STAFF REPORT: 06/11/2025

APPLICATION NUMBER: HDC2025-00134

ADDRESS: 1659 LONGFELLOW

SCOPE: REPLACE FRONT FAÇADE WINDOWS

Photo from the most recent listing, posted on 01/22/2025

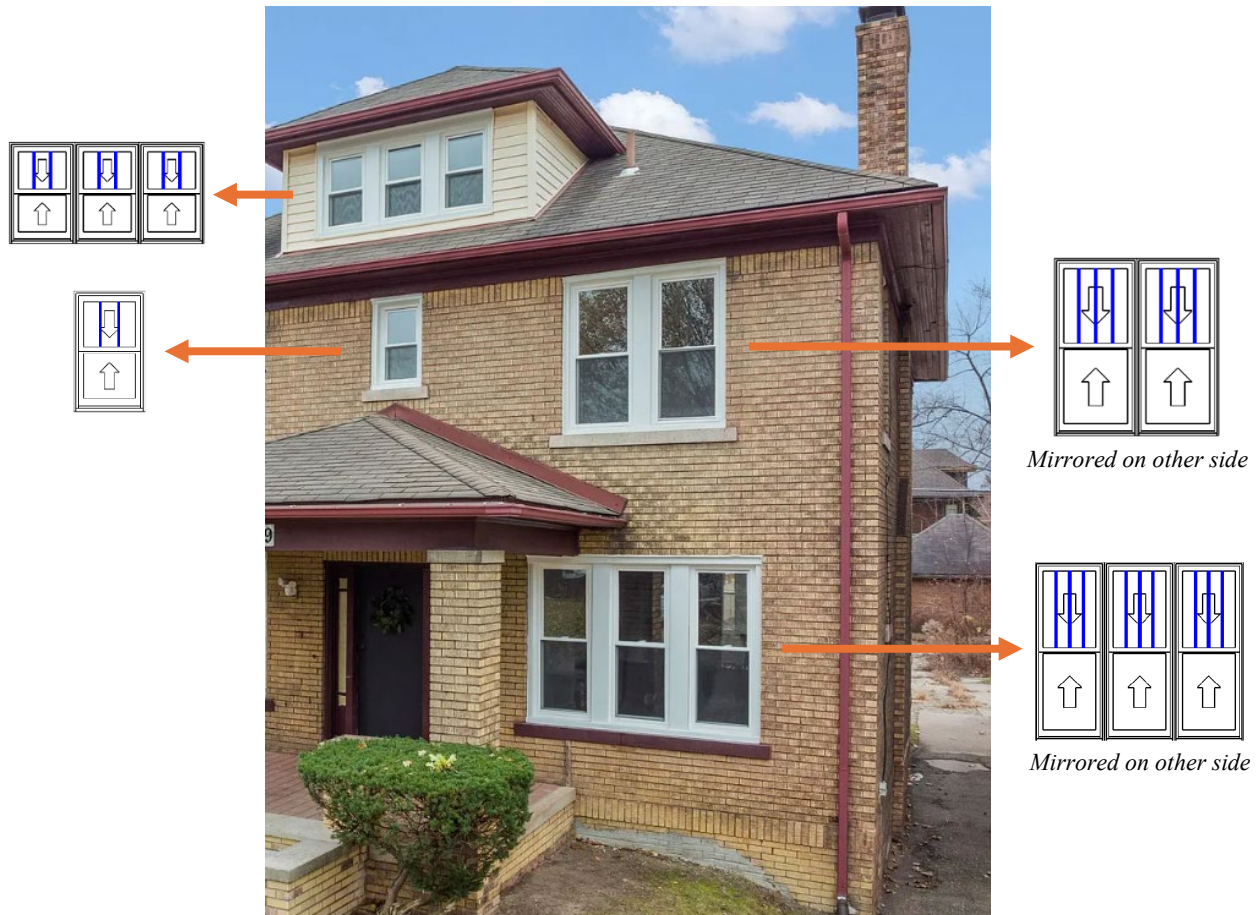
- The applicant did not provide photographs of the existing conditions of the original wood brickmold and mullions, but interior photos from the listing, the original mullions seem to still exist after the installation of the vinyl windows, as shown in below photo.

- The existing wood mullions and wood brickmold are distinctive character-defining features that have not been proven to be beyond feasible repair.
- The Elements of Design (Sec. 21-2-106) mention that “several windows are sometimes grouped into a combination that is wider than tall” and that “window openings are always subdivided.” Additionally, “wood is almost universally used for window frames and other functional trim and is used in many examples for all trim.”

- The proposed factory mullied units will remove the character-defining and distinctive historic wood mullions.
- The color for the proposed windows is not compatible with the house.

- Individual window units instead of multi-window units to retain the historic wood brickmold and mullions, with HDC staff to review the new window order.
- The proposed aluminum clad windows and surround shall be painted an exterior color according to the HDC color chart system E for this house.
